APPLICATION NO.	FILING DATE	FIRST NAMED INVENTOR	ATTORNEY DOCKET NO.	CONFIRMATION NO.
10/574,741	01/16/2007	Otto Bosse	10537/328	2477
26646 KENYON & K	7590 01/07/200 ENYON LLP	EXAMINER		
ONE BROADY		AMIRI, NAHID		
NEW YORK, NY 10004			ART UNIT	PAPER NUMBER
			3679	
			MAIL DATE	DELIVERY MODE
			01/07/2009	PAPER

Application No.	Applicant(s)				
	10/574,741	BOSSE ET AL.				
Office Action Summary	Examiner	Art Unit				
	NAHID AMIRI	3679				
The MAILING DATE of this communication app Period for Reply	ears on the cover sheet with the c	orrespondence address				
A SHORTENED STATUTORY PERIOD FOR REPLY WHICHEVER IS LONGER, FROM THE MAILING DA - Extensions of time may be available under the provisions of 37 CFR 1.13	ATE OF THIS COMMUNICATION	ĺ.				
<ul> <li>after SIX (6) MONTHS from the mailing date of this communication.</li> <li>If NO period for reply is specified above, the maximum statutory period w</li> <li>Failure to reply within the set or extended period for reply will, by statute, Any reply received by the Office later than three months after the mailing earned patent term adjustment. See 37 CFR 1.704(b).</li> </ul>	cause the application to become ABANDONE	D (35 U.S.C. § 133).

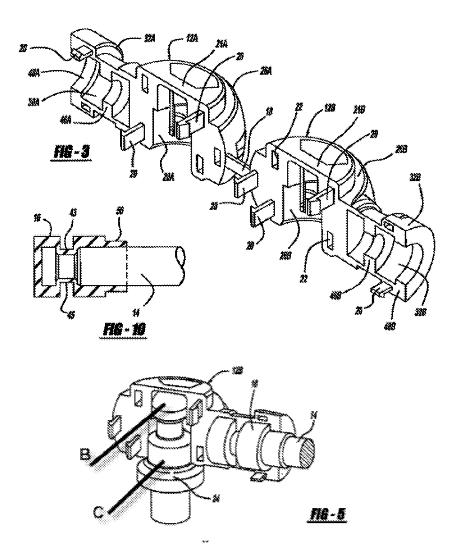
With respect to claims 14-20, Gordy et al. disclose a ball socket (Figs. 3, 5, 10) for receiving a ball (B) comprising a first half-socket (26A) and a second half-socket (26B), each of the first half-socket (26A) and the second half-socket (26B); at least one elastically deformable region (18) integrally formed with the first half-socket (236A) and the second half-socket (26B), wherein the elastically deformable region (18) is in a load-free state when the ball in completely inserted into the ball socket; wherein the elastically deformable region (18) is formed of an elastically deformable material; wherein the elastically deformable region (18) includes an elastically deformable geometry; wherein the ball socket is adapted to cover a ball portion (B) of the ball delimited by at least one circle; and wherein the socket includes at least one gap (constituted by a cover a distance between the first half-socket and the second half socket; an wherein the gap is oriented perpendicular to at least one circle that delimits a ball portion (B) of

the ball that is covered by the ball socket. With respect to the second half socket having at least partially spherical interior surface, the breadth of this recitation (note the inclusion of "at least partially") is deemed to include the interior surface of Gordy et al because a single circumferential line circumscribing the interior thereof is all that is necessary to meet the broad "at least partially" recitation. However, assuming arguendo that the entire interior surface must be of a configuration approaching that of a spherical surface, then it would have been obvious to one of ordinary skill in the art at the time of invention was made, as a matter of engineering design choice, to provide the interior surface of the half-socket of the Gordy et al. with at least partially interior surface in order to provide surface to surface engagement with the spherical portion of the ball.

With respect to claims 21 and 22, Gordy et al. disclose (Figs. 7, 8) that the elastically deformable region (18) is arranged as an elongate portion arranged diagonally with respect to the gap; and wherein the at least one gap includes two gaps (constituted by distance between two end portions of the first and second half sockets. arranged diagonally with respect to one another along a circumference of the ball.

With respect to claims 23-26, Gordy et al. disclose that the elastically deformable region (18) is arranged in one of the two gaps; wherein the elastically deformable region (18) is arranged between a first portion of the circle and a second portion of the circle; and wherein the elastically deformable region (18) includes a thin-walled region.

With respect to claims 27 and 28, Gordy et al. disclose a system (Figs. 3, 5, 10) comprising a rotatably mounted connection arrangement adapted to connect a first part (constituted by a pin 24) to a second part (constituted by parts 12A, 12B), the first part (24) including a ball (B) as a connection element (C), the second part (12A, 12B) including a first half-socket (26A), a second half-socket (26B), each of the first half socket (26A) and the second half-socket (26B) having an at least partially spherical interior surface at least one elastically deformable region (18) integrally formed with the first half-socket (236A) and the second half-socket (26B), wherein the elastically deformable region (18) is in a load-free state when the ball in completely inserted into the ball socket.

With respect to the "at least partially spherical" recitation, Examiner notes that it is unclear what exactly constitutes the second half-socket having at least partially spherical. Meanwhile, Fig. 3 shows clearly the inside of the housing pieces 12A, 12B is at least partially

spherical, in the broad sense, along any single circumference line of the interior and when the ball portion inserted into the ball socket the hinge 18 would be in a load-free state.

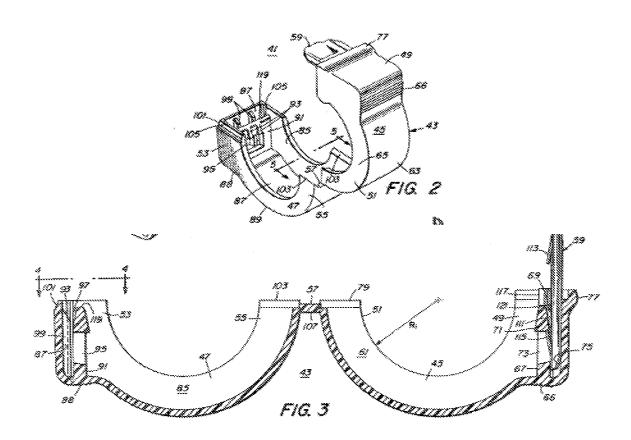
With respect to claims 14-20, Nielsen, Jr. discloses a socket (43, Figs. 2, 3) which capable of receiving a ball comprising a first half-socket (45) and a second half-socket (47), each

of the first half-socket (45) and the second half-socket (47) having an at least partially spherical interior surface (85, 87); at least one elastically deformable region (57) integrally formed with the first half-socket (45) and the second half-socket (47), wherein the elastically deformable region (57) inherently is in a load-free state when the ball in completely inserted into the socket; wherein the elastically deformable region (57) is formed of an elastically deformable material; wherein the elastically deformable region (57) includes an elastically deformable geometry; wherein the socket (43) is cable of covering a ball portion of the ball delimited by at least one circle; and wherein the socket (43) includes at least one gap (constituted by a distance between the first half-socket 45 and the second half socket 47); and wherein the gap is oriented perpendicular to at least one circle that delimits a ball portion (B) of the ball that is covered by the ball socket.

With respect to claims 21 and 22, Nielsen, Jr. discloses (Figs. 2, 3) that the elastically deformable region (57) is arranged as an elongate portion arranged diagonally with respect to the gap; and wherein the at least one gap includes two gaps (constituted by distance between two end portions of the first and second half sockets (45, 47) which inherently could arranged diagonally with respect to one another along a circumference of the ball.

With respect to claims 23-26, Nielsen, Jr. discloses (Figs. 2, 3) that the elastically deformable region (57) is arranged in one of the two gaps (defined be distances between two half-sockets; wherein the elastically deformable region (57) is arranged between a first portion of the circle and a second portion of the circle; and wherein the elastically deformable region (57) includes a thin-walled region.
